# Technical Service Bulletin

Mazda North American Operations  
Irvine, CA 92618-2922

<b>Subject:</b>  REAR BRAKE NOISE	<b>Bulletin No.:</b> 04-001/24
	<b>Last Issued :</b> 08/29/2024

SECTION A-A

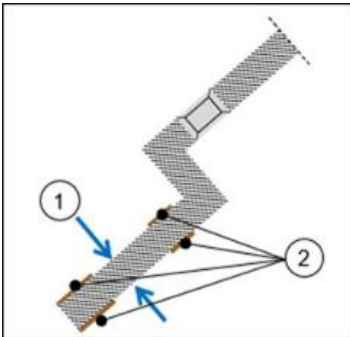
- Check the disc thickness using a micrometer before lathing, if the thickness is below 8.7 mm for 2WD or 9.7 mm for AWD, replace the disc with new ones (DO NOT lath). Measure the thickness in the relatively less rusted area where the pads are hitting but not in the severely rusted area.
- Disc replacement is acceptable if an on-car lathe is not available.

Sample case: If lathe is not applicable.  
Some areas of the surface have fallen off due to rust and are too thin.

**NOTE:** Measure the thickness at the least rusted area.

- (1) Measuring points  
(2) Rust
